This letter is to inform you that my company pumped out and abandoned the Septic (Cesspool) located at 6460 Elibank Ellicott City, Md.

SITE INSPECTION SHEET

OWNER: _____ PHONE #: _____
ADDRESS: 10460 Elibank CONTRACTOR: _____
SUBDIVISION: _____ LOT: _____ COUNTY #: _____
PROPOSAL: BP # B07000104 Renovate existing historic home

LOCATION DIAGRAM

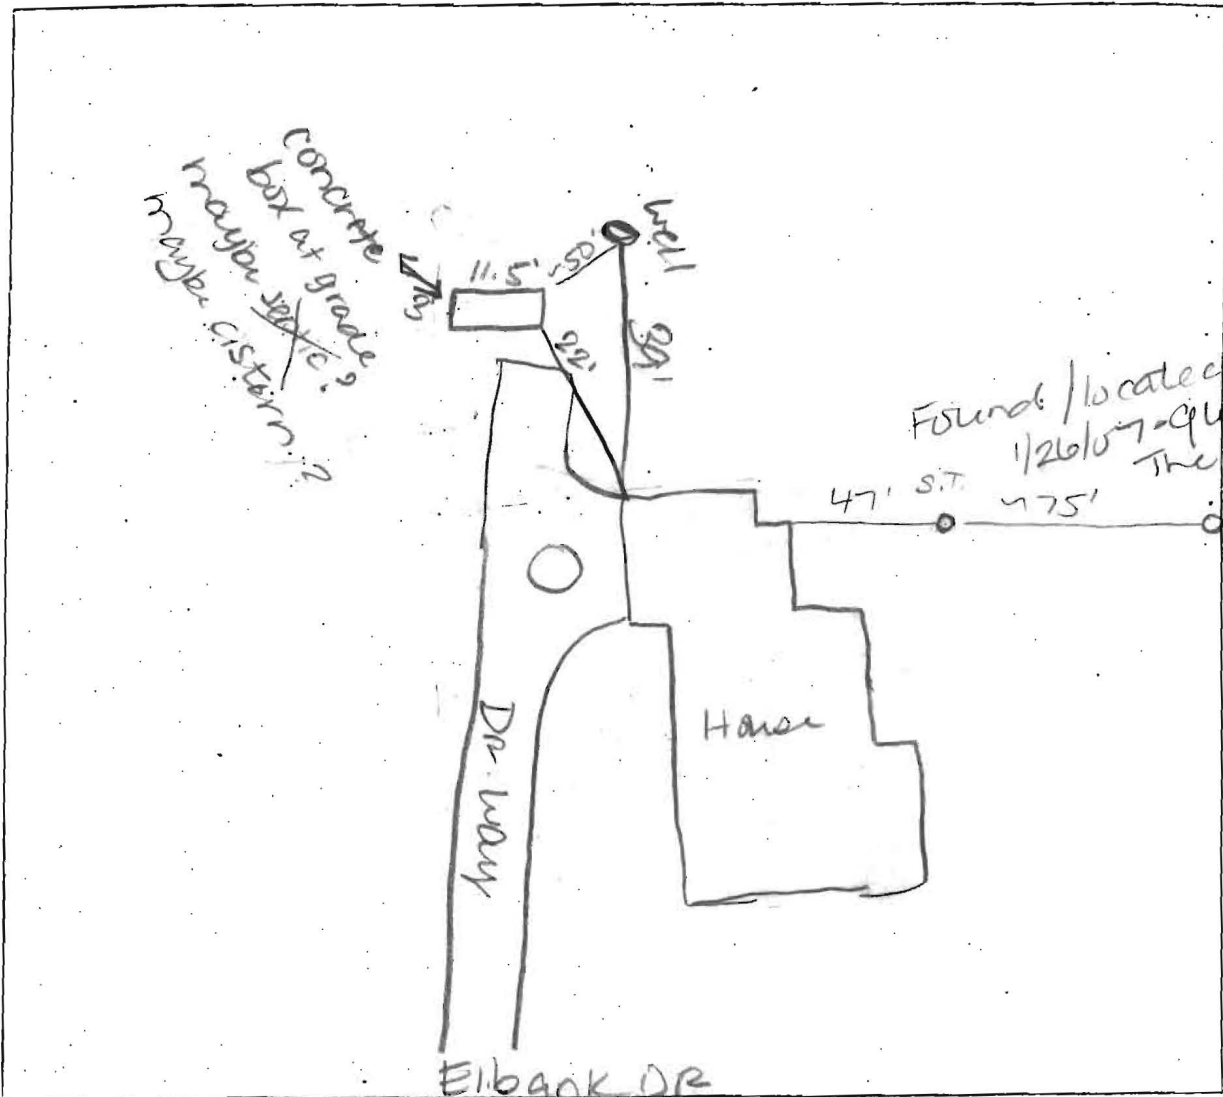
COMMENTS: 1/23/07
well 8" above grade casing has started to rust
public water is available / sewer is not per planning + zoning
owner is saying that septic is being pumped
from manhole in the road. 1/20/07 owner had Fugle's (AT)
come out to locate septic. found tank + dry well. coming back to
open tank.

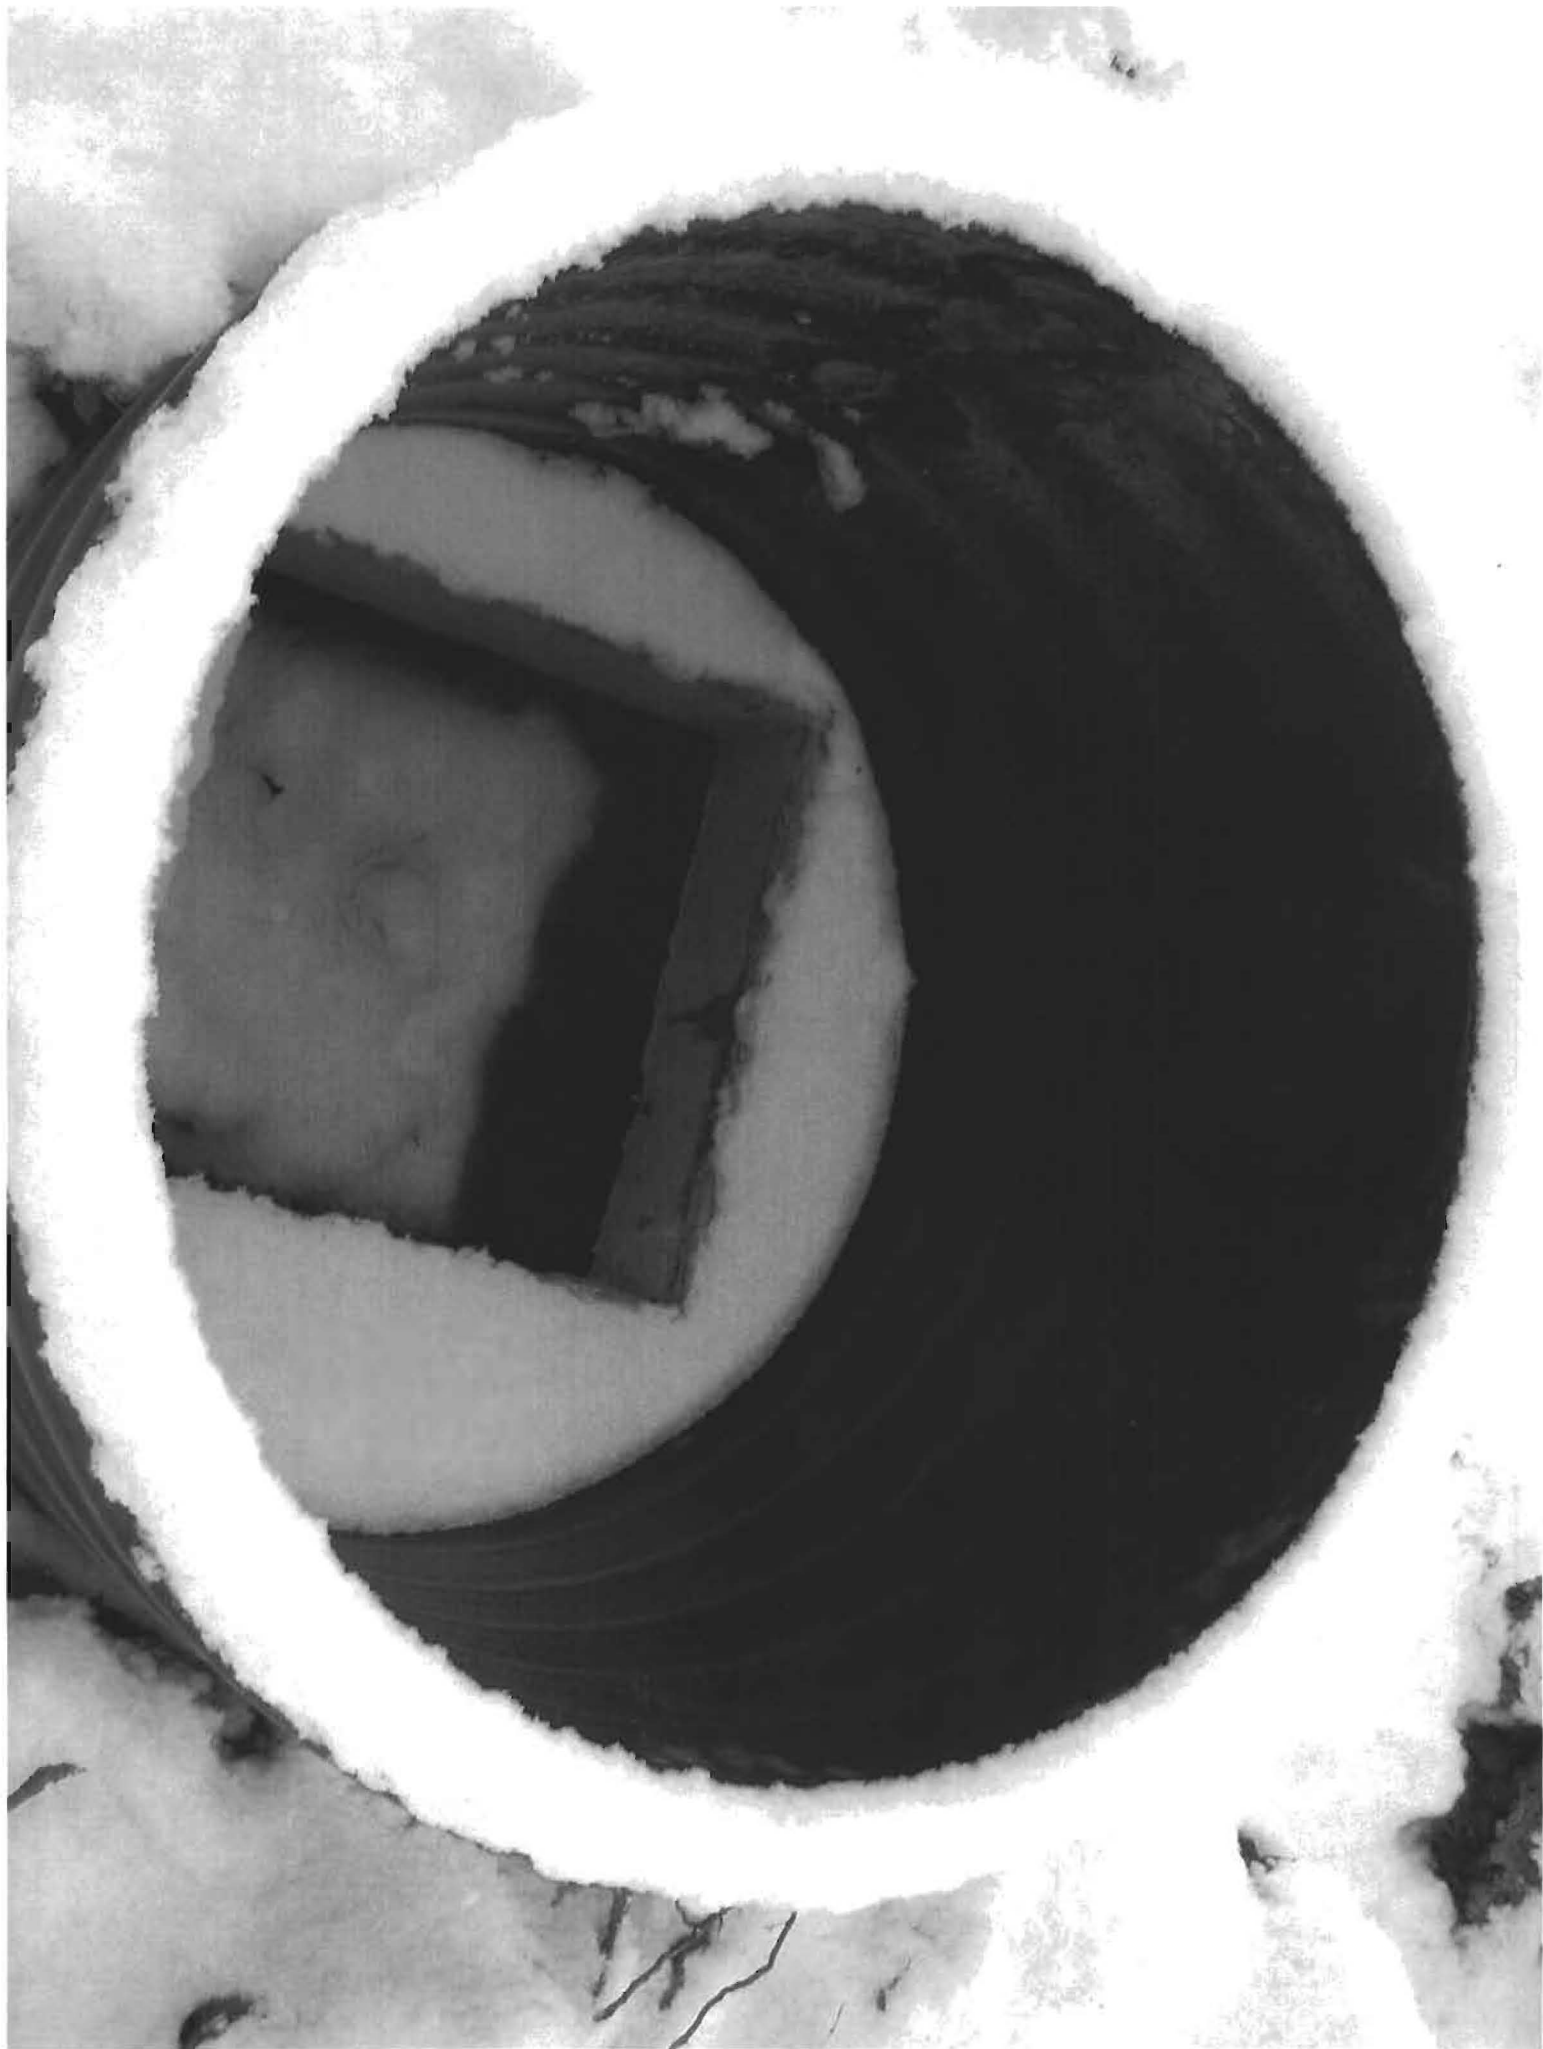
still opened + exposed + full

3/12/07
